Re: PUC Case No. PU-08-75

Enclosed is a supplemental filing to Basin Electric's Late-Filed Exhibit #2, Minot Air Force Base, filed on May 26, 2009. The supplemental filing consists of a series of e-mail communications between Mr. James C. Sheldon, a Basin Electric engineer, and Mr. David Pooley of the U.S. Air Force.

## Custom Microwave Report

PrairieWinds 1

Figure 3: Microwave Paths with WCFZ Buffers

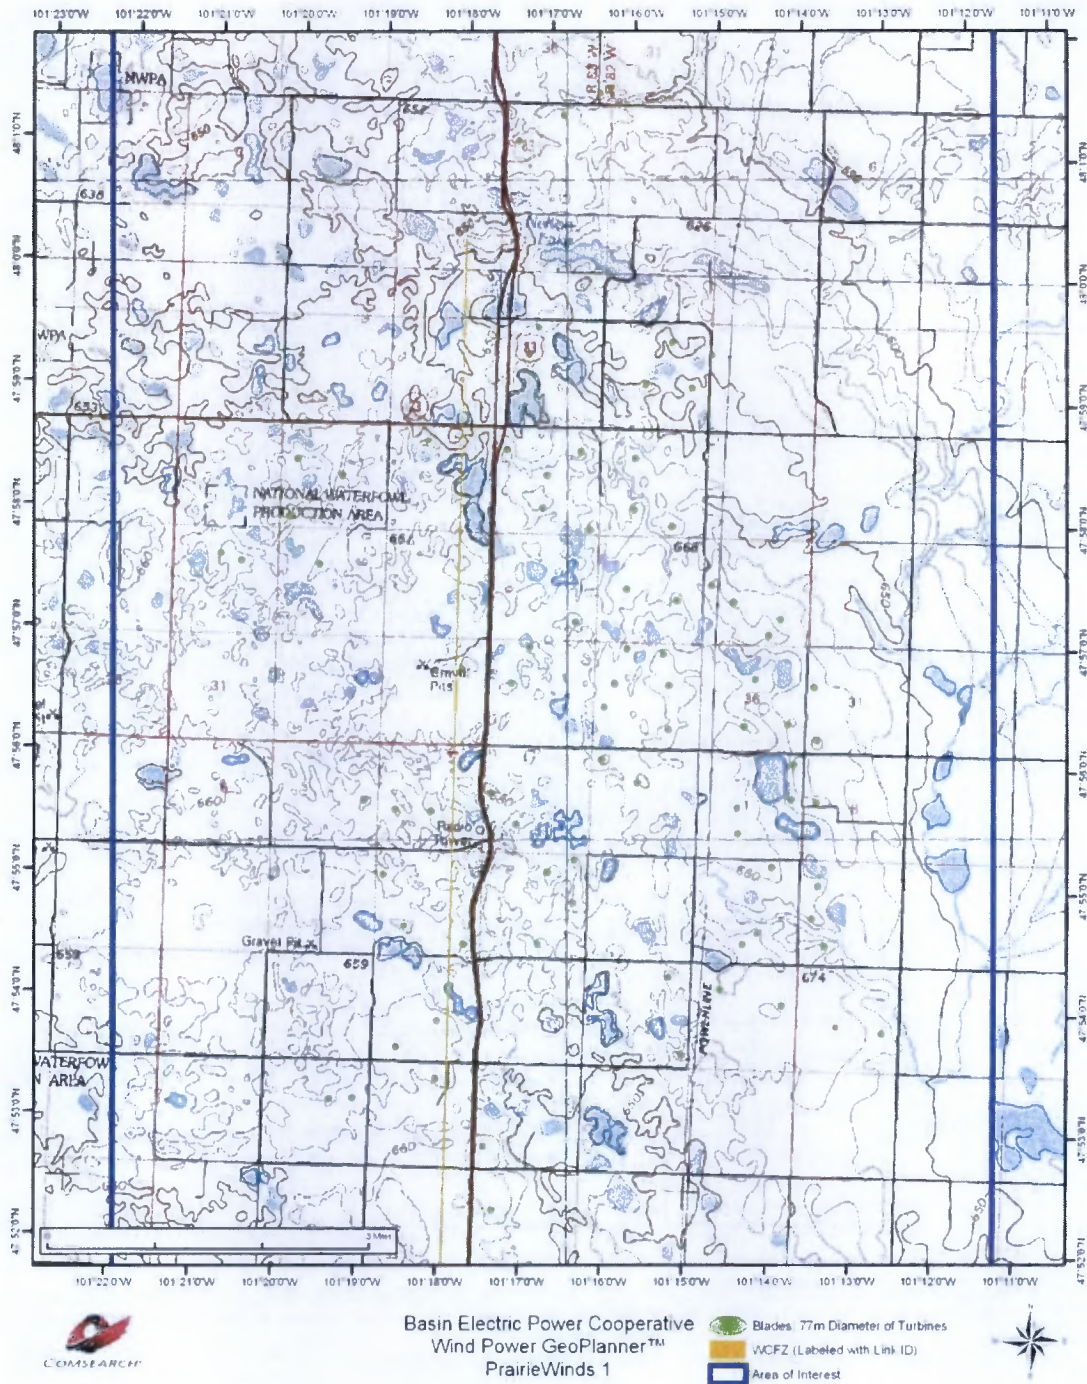
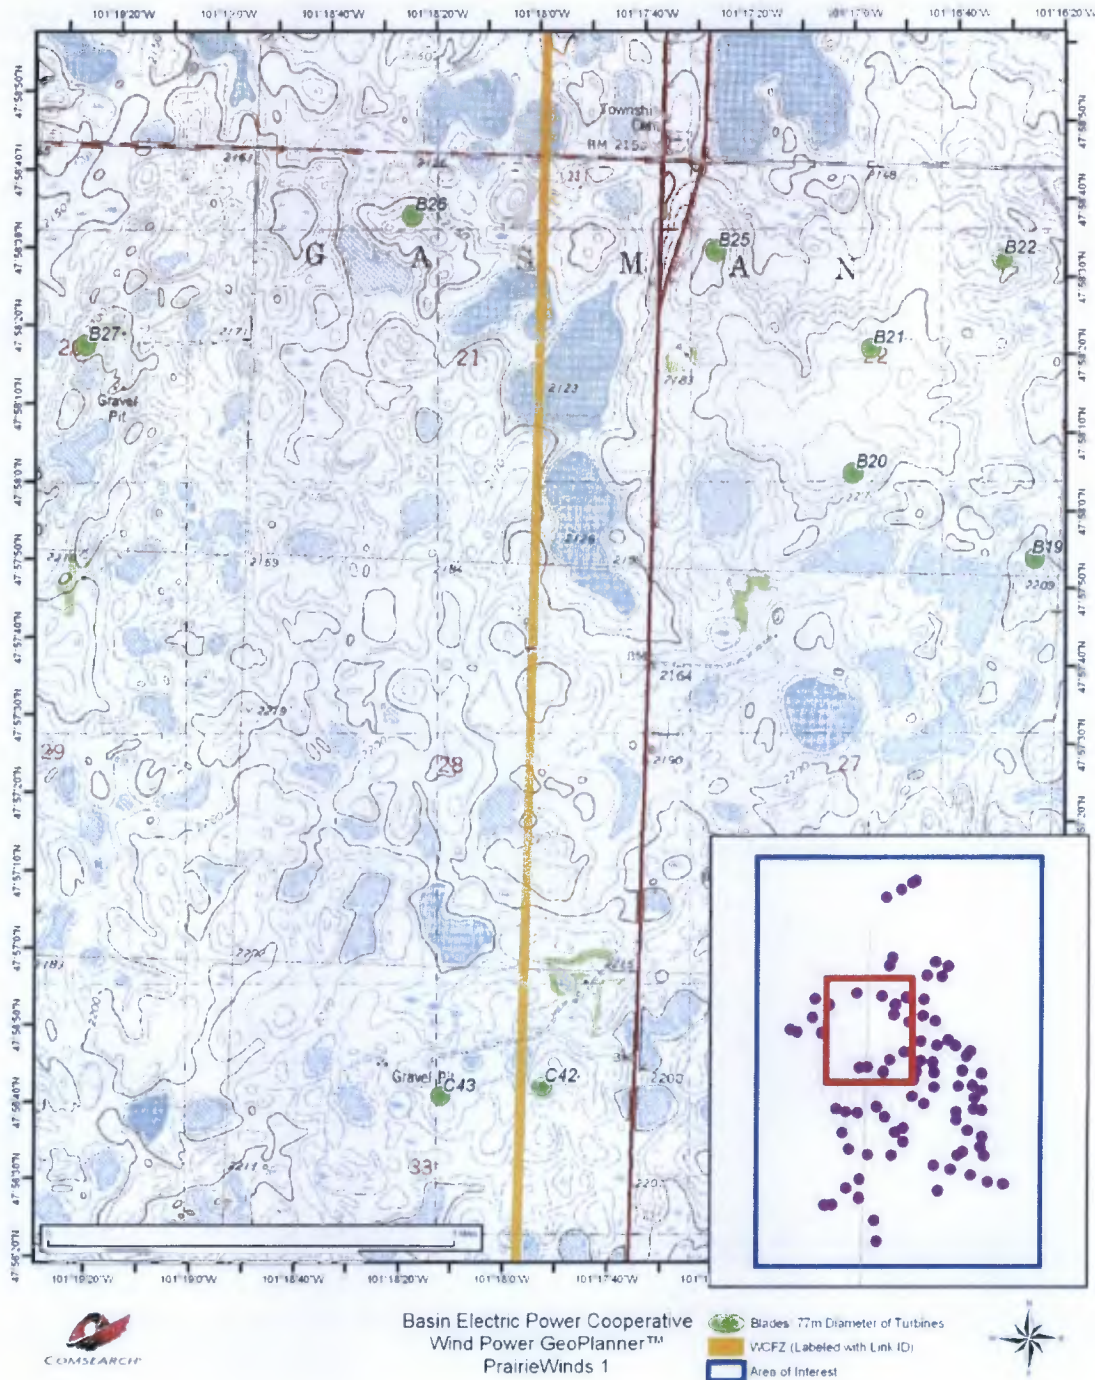
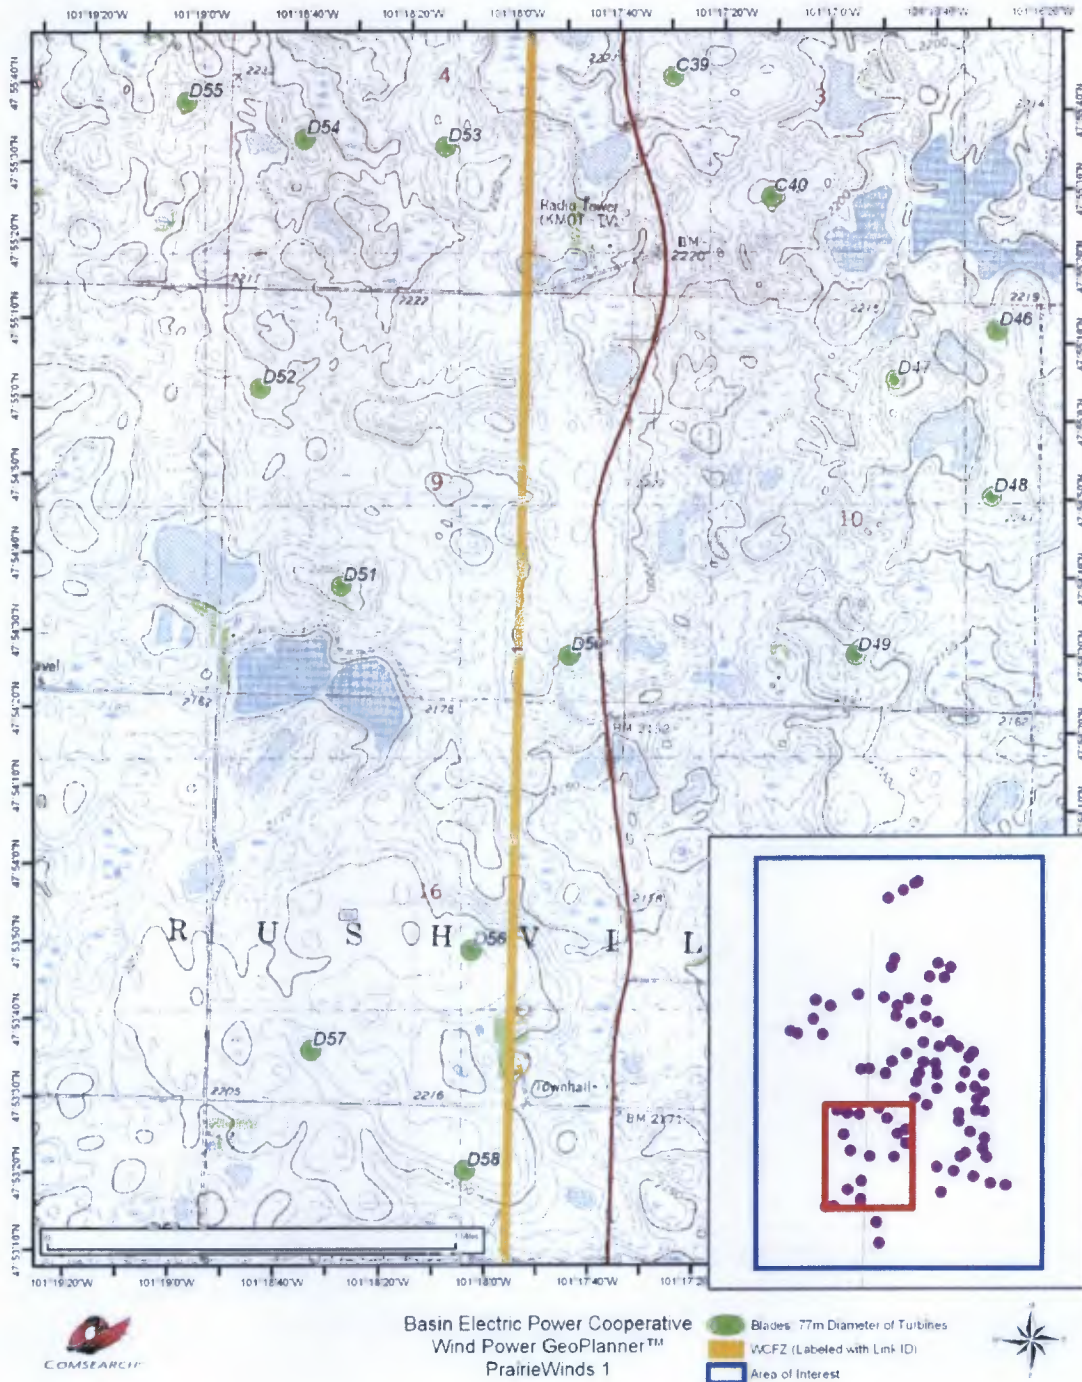
Recommend having Comsearch review sites C42, C43, D50, D53, D56 & D58. That way we both have documentation supporting no impact. I believe Comsearch uses Microwave GeoPlanner and should be able to generate a report fairly quickly.

None of the turbines were found to have a potential conflict with the incumbent microwave path. Turbine C42 was the closest to the WCFZ at a distance of 28.2 meters, but no obstruction is predicted. However, due to the close proximity of multiple turbines to the WCFZ, accuracy of the coordinates is a critical component of the analysis. Comsearch used coordinates provided by the US Air Force under the assumption that they were accurate.
